RFI #170: LSFS #4 & 5 UL Assembly at the Elevator Door

Status	Open		
To	Edgar Flores (GLMV Architecture) Chad Bard (GLMV Architecture)	From	Nate Henson (McCownGordon Construction, LLC) 850 Main Street Kansas City, Missouri 64105
Date Initiated	Dec 4, 2023	Due Date	Dec 7, 2023
Location	Fire Station 4 & 5	Project Stage	
Cost Impact	TBD	Schedule Impact	No
Spec Section		Cost Code	
Drawing Number	A-411	Reference	
Linked Drawings			
Received From	Nate Henson (McCownGordon Construction, LLC)	Sub Job	
Copies To	Andrew Calderwood (McCownGordon Construction, LLC), Nate Henson (McCownGordon Construction, LLC), Chloe Huxol (McCownGordon Construction, LLC), Mike Morgan (McCownGordon Construction, LLC)

DESIGN NO. UL U415 UL System A

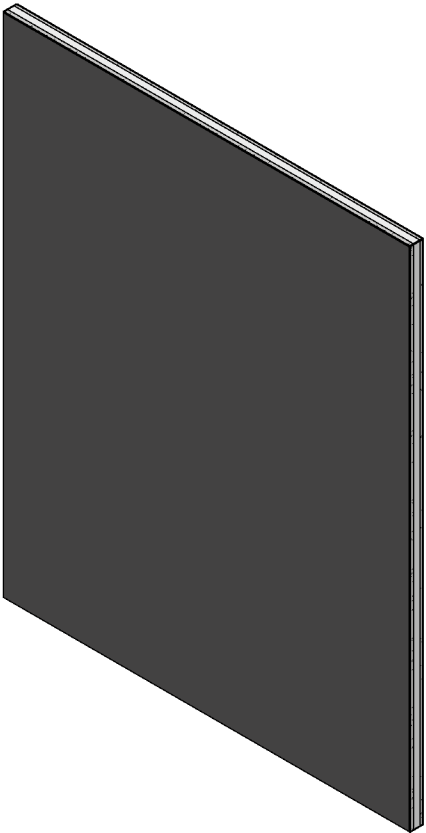
We would like to switch the masonry infill at the elevator door jamb on the 1st and 2nd floor to a shaftliner assembly (UL Attached).
The elevator indicator light, call button and fire dept. call buttons will be on opposite sides of the elevator door on each floor as discussed.

1. The switch from masonry infill to a shaftliner assembly is **ACCEPTABLE**, if wall ratings remain the same.

2. The elevator indicator light, call button and fire dept. call buttons being on opposite sides of the elevator door on each floor is **ACCEPTABLE**, if mounting heights remain the same.
